VICTORIAN CIVIL AND ADMINISTRATIVE TRIBUNAL

VCAT REFERENCE NO. P413/2022
PERMIT APPLICATION NO.TPA/52962

Application under section 77 of the *Planning and Environment Act 1987* to review the refusal to grant a permit; Monash Planning Scheme; General Residential Zone; four triple storey dwellings; Mount Waverley Activity Centre; Garden City and neighbourhood character; amenity and landscaping

APPLICANT	Tanner Land Pty Ltd
RESPONSIBLE AUTHORITY	Monash City Council
RESPONDENTS	Sarah Dowe Julie Johnson, Sylvia Williams, Jack Kirszenblat, Edward Sullivan and Anastasios (Tom) Pragastis executor/trustee for Demetria Pragastis's estate
SUBJECT LAND	18 Holskamp Street MOUNT WAVERLEY VIC 3149
HEARING TYPE	Hearing
DATE OF HEARING	14 October 2022
DATE OF ORDER	17 November 2022
CITATION	Tanner Land Pty Ltd v Monash CC [2022] VCAT 1316

Figure 5: Landscape plan evidence

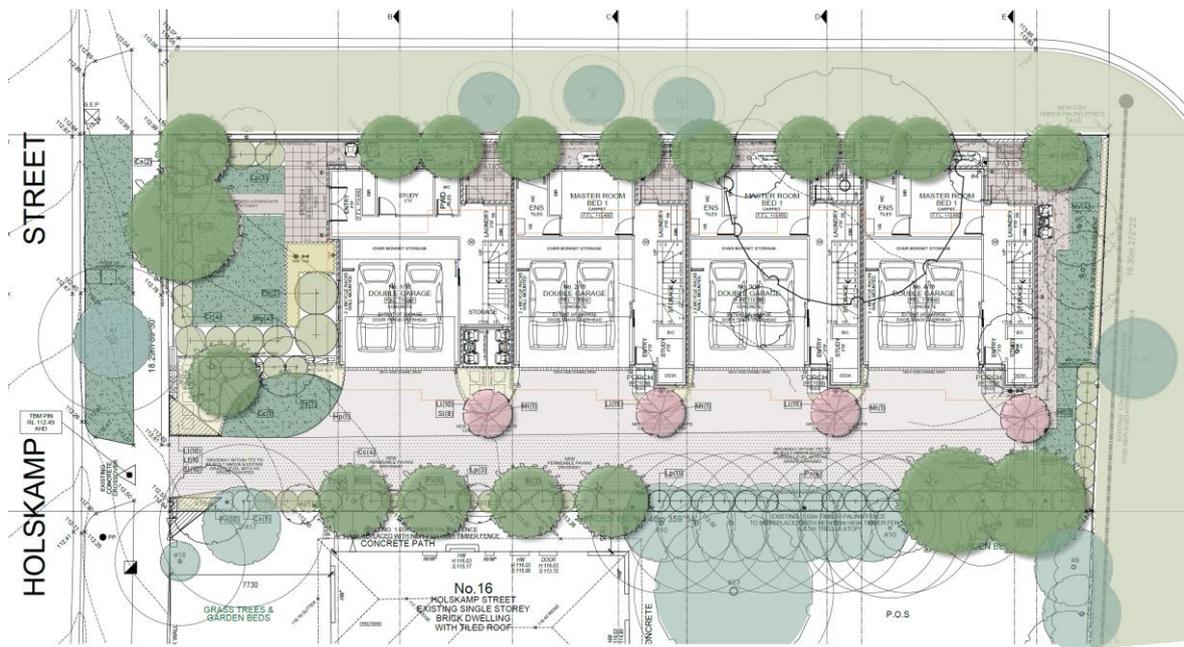
- 45 Mr Boyle's evidence included a landscape plan (refer to Figure 5) which significantly embellished the landscaping that was proposed in the permit application. I note that under questioning, Mr Boyle acknowledged that he prepared the landscape plan based on the existing proposal and that he was not instructed to revise the design or to consider existing vegetation. This puts into context that the landscaping design has worked around the constraints offered by the design of the proposal.

- 46 I accept the landscaping that is proposed in the evidence with respect to the front setback and along the proposed driveway. I consider what is proposed will achieve an acceptable outcome. It is notoriously difficult to avoid gun-barrel driveways with tandem medium density residential development. The proposed landscaping response in Mr Boyle's evidence provides plantings along both sides of the driveway which will assist with dwelling

- 47 Regarding boundary planting, I am generally satisfied except for the setbacks for the eastern side boundary and the southern rear boundary, which are insufficient. I acknowledge that the existing canopy trees are to be removed including Trees 5 and 6 on the rear boundary. However, I consider it appropriate to require increased setbacks to allow for additional canopy tree planting to be provided that better responds to policy and the leafy garden city character the site and neighbourhood exhibits.

- 48 I agree with Council and the objectors that there is too much reliance on landscaping outside the site. The proposal needs to respond in a more positive manner.

- 49 I find the space for landscaping along the eastern and southern boundaries of the site should be increased and I will include conditions requiring the rear setback to be increased to 5 metres and for the eastern setback to be increased to 3 metres. Both will allow for canopy trees to be planted that will achieve a height that matches the built form height of the proposal.

- (a) The changes required under Conditions 1(a) and 1(b);
- (b) A balance of planting along the eastern boundary between the canopy trees required under Condition 1(a) and a reduction in the number of Native Frangipanis to provide appropriate spacing;
- (c) Reduced paving within the ground level open space of each dwelling and replaced with lawn;
- (d) The extent of any cut, fill, embankments or retaining walls associated with the landscape treatment of the site;
- (e) The detail of the proposed paving;
- (f) The location and operational detail of external lighting (if any); and
- (g) The provision of an in-ground, automatic watering system linked to rainwater tanks on the land servicing the main garden areas,
